Planned Unit Development – Bear Creek

**CITY OF LA VISTA
PLANNING DIVISION
RECOMMENDATION REPORT**

CASE NUMBERS: PPUD23-0006; PCUP23-0010; PRP23-0004
FOR HEARING ON: JUNE 6, 2024; REPORT PREPARED ON:
MAY 30, 2024, REPORT REVISED ON JUNE 6, 2024

PUD Phasing Plan

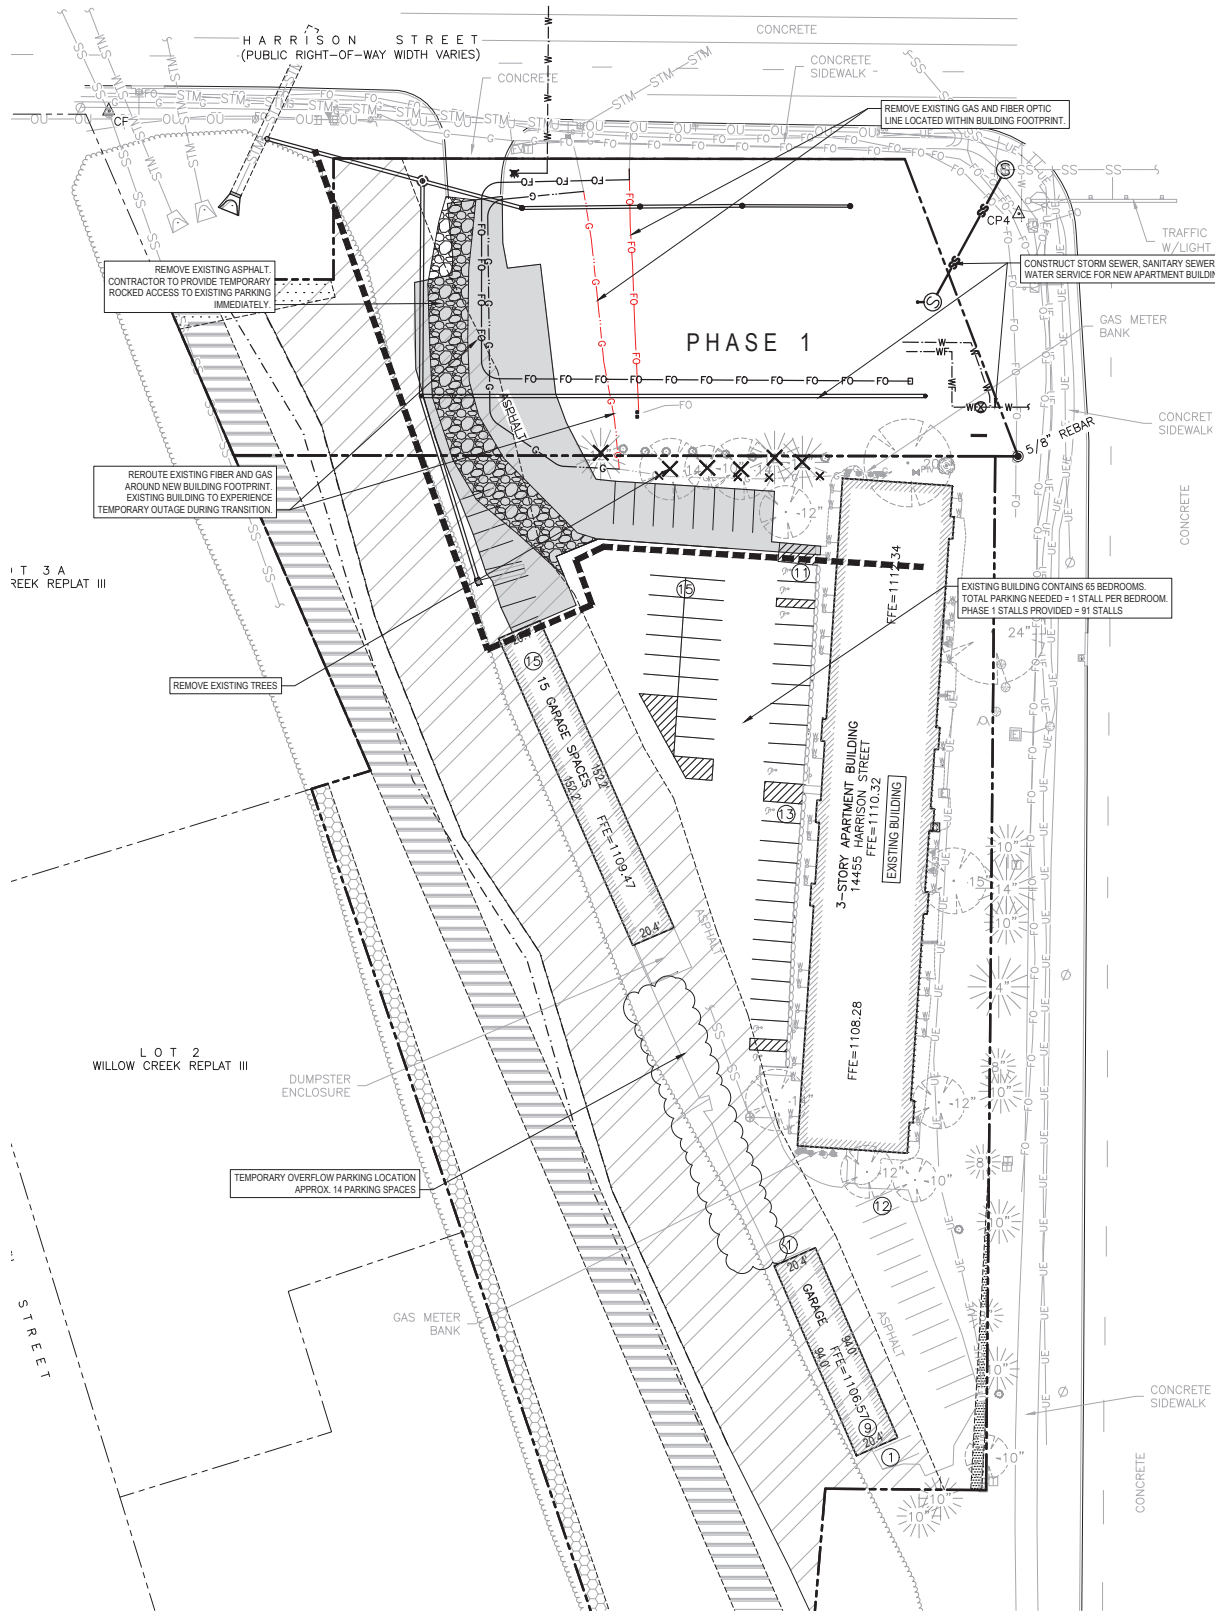
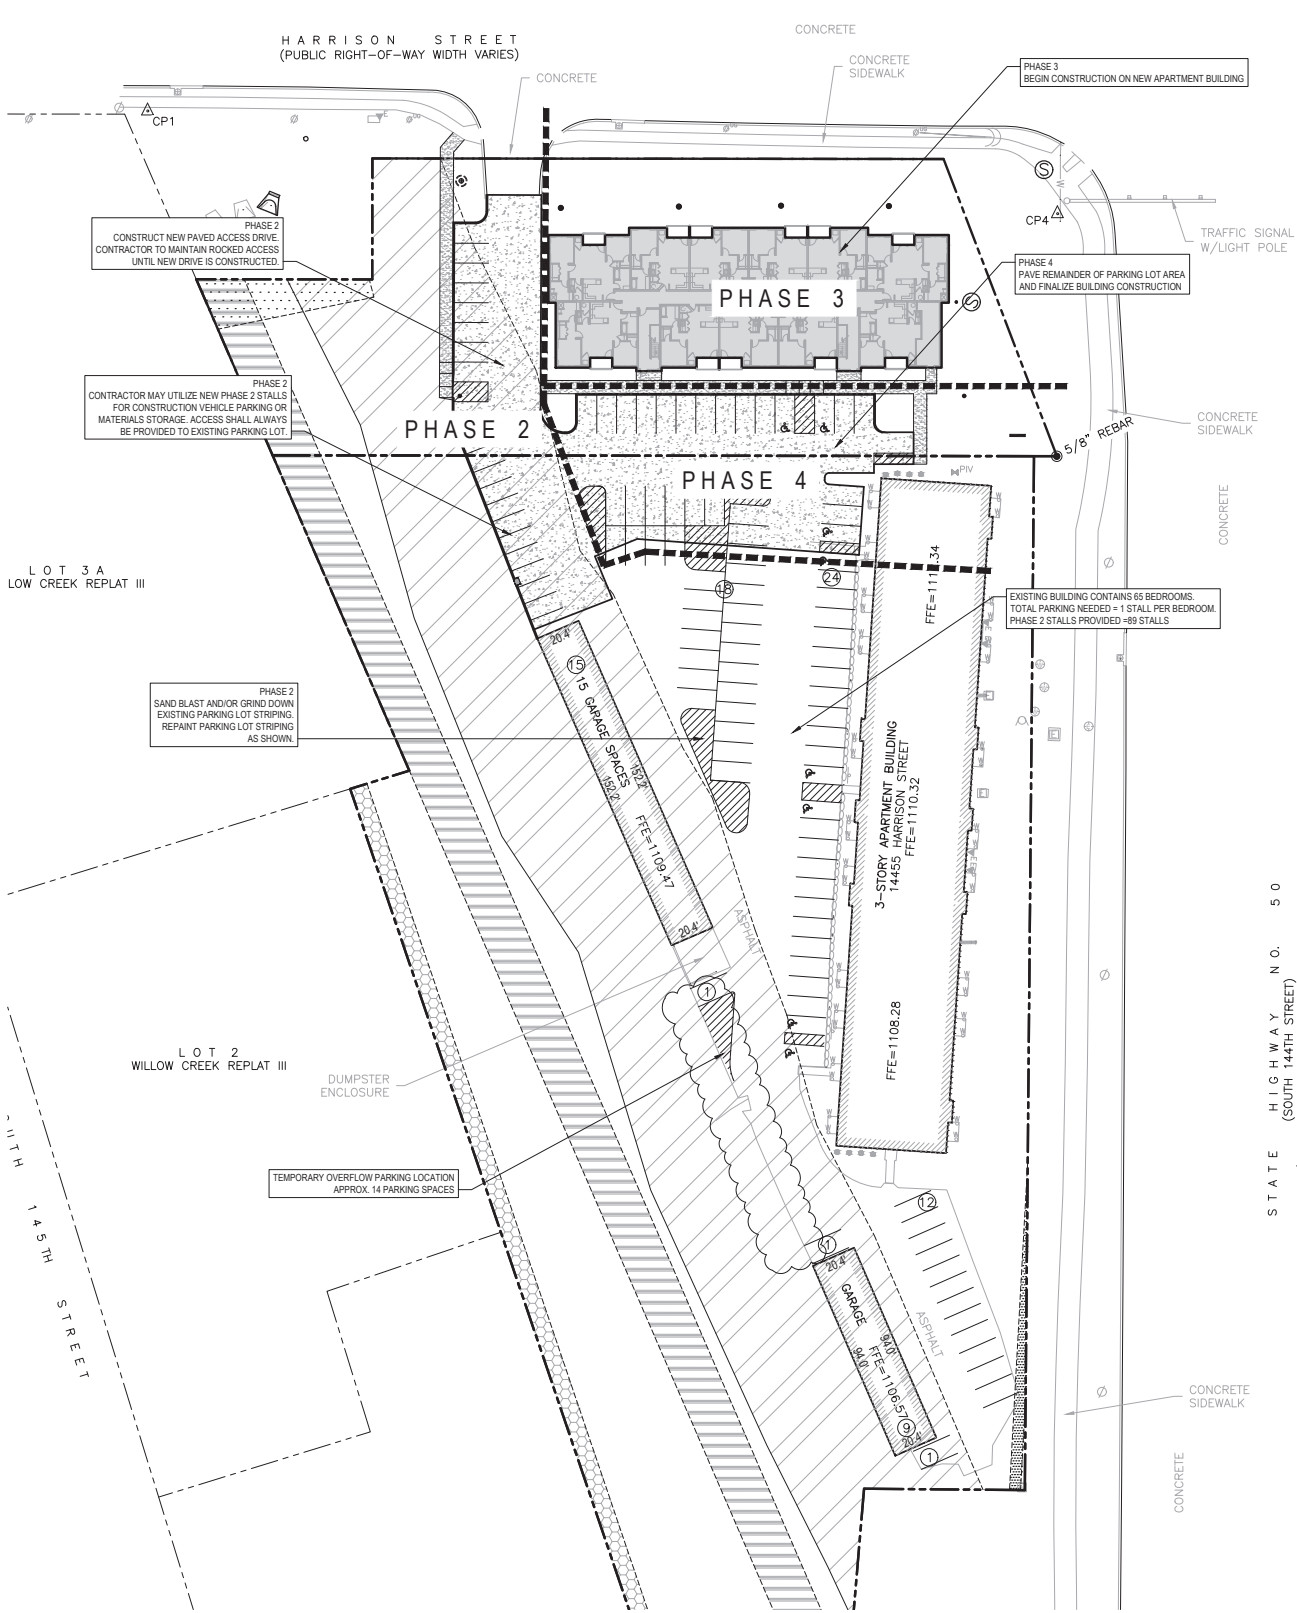
1. Regarding Section 5.15.04.01, please include a proposed construction schedule with submittal, inclusive of any contemplated phasing.
2. Regarding Section 5.15.04.04, please provide a staging plan and/or phasing exhibit to ensure that ingress and egress/access, and adequate parking counts are able to be maintained, and that all utilities/current services can still be provided to the residences in Lot 2, during the construction on Lot 1.
3. Regarding Section 5.15.04.13 & 5.15.05.03, provide an exhibit or narrative of what areas are to be considered common open spaces and provide documentation as to how said common spaces between Lots 1 and 2 are to be maintained in perpetuity.

1. Regarding Section 5.15.04.01, please include a proposed construction schedule with submittal, inclusive of any contemplated phasing.
A proposed construction/phasing plan has been included in this resubmittal.

2. Regarding Section 5.15.04.04, please provide a staging plan and/or phasing exhibit to ensure that ingress and egress/access, and adequate parking counts are able to be maintained, and that all utilities/current services can still be provided to the residences in Lot 2, during the construction on Lot 1.
A proposed phasing plan has been included in this resubmittal. The contractor shall provide a rocked/gravel access path until the paved drive is reconstructed. There will be a brief interruption to the gas and fiber optic service during the transition to the rerouted lines.

PLANT SCHEDULE

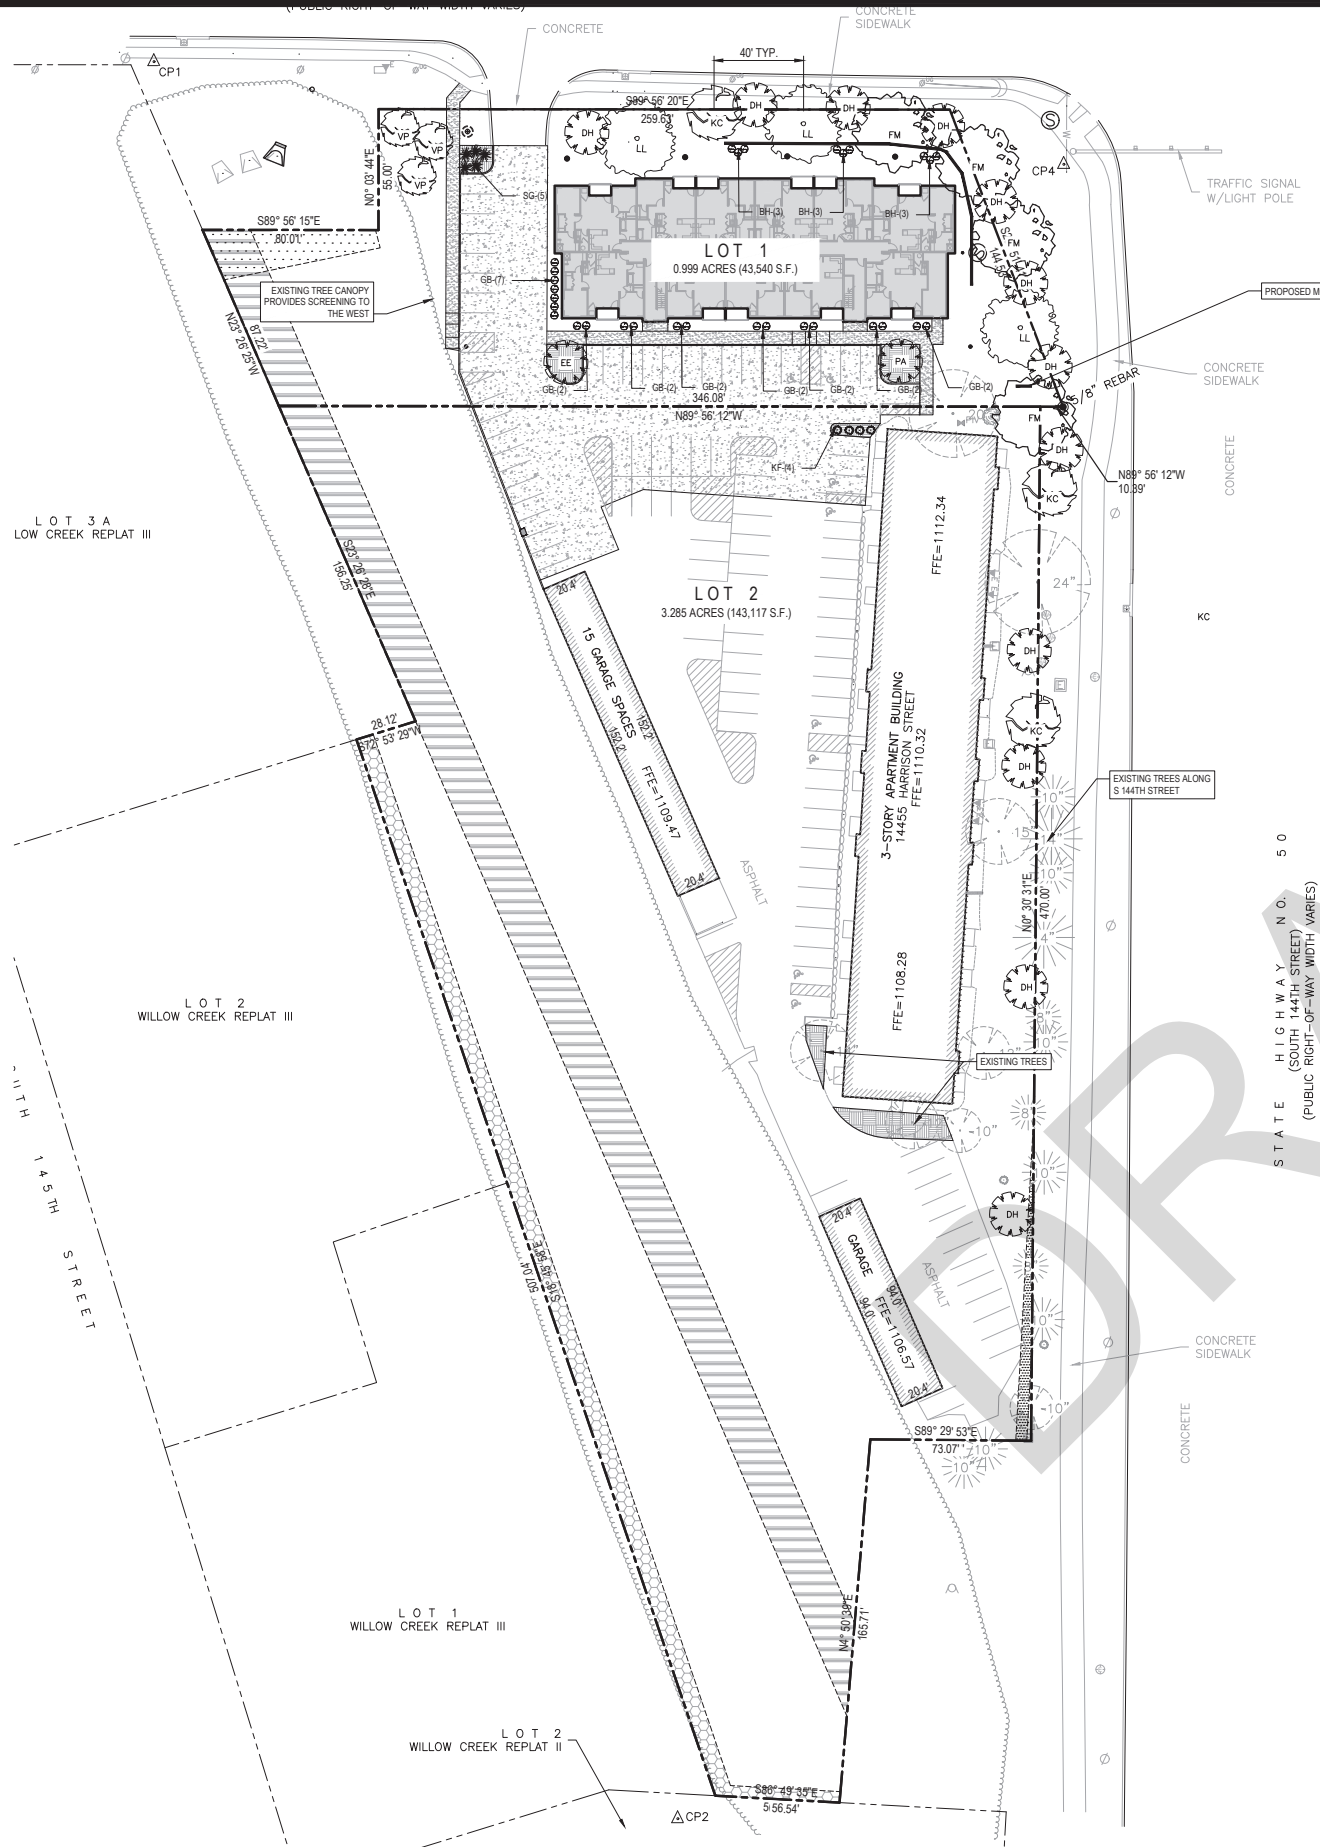
1. Landscaping
 - i. Per 4.III.D.2, a minimum of one species of deciduous shrub is required, none are included in the plant schedule.
 - ii. Irrigation required per 4.III.G not indicated on plans.

Recommend additional landscaping between buildings, parking lots and drive lanes to soften the transition between pavement and the buildings. This could include plantings from Appendix G.

Recommend landscape along Harrison Street and 144th Street which includes elements from Appendices B and C from the Architectural and Site Design Guidelines for the Southport Development. These items include but are not limited to berms, street trees, shrubs and other low plantings.

1. Please find attached as Exhibit A the initial review letter from the City's third-party design review architect regarding changes required for the property come into compliance with the Gateway Corridor Overlay District's landscaping requirements. Please make the necessary changes to the landscaping plan, inclusive of irrigation for the landscaping areas along Harrison Street and S. 144th Street and resubmit to the City for further review.
Bobo Hydrangea have been added to the planting schedule and are shown along the retaining wall on the north side of the proposed apartment building. Note no. 4 has been added to the Landscaping Notes stating that all proposed landscaped areas shall receive irrigation, including landscaping along 144th & Harrison Street.

2. Beyond the changes referred in comment #1 above that are required to satisfy the requirements of the Gateway Corridor Overlay District, as a condition for the use of the Planned Unit Development tool to reduce the required front yard setbacks along S. 144th Street, additional landscaping areas shall be provided in accordance with the letter from the City's third-party design review architect attached as Exhibit B.
Additional shrubs have been added between the parking lot and building as outlined in Exhibit B, as well as additional shrubs along the north retaining wall. A smaller, more ornamental tree has been added to the planting schedule along 144th & Harrison Street as outlined in Appendices B and C of the Southridge Design Guidelines. The selected tree, Downey Hawthorne, is identified in Appendix G of the Southridge Design Guidelines and is intermixed with the overstory trees along 144th & Harrison Street.
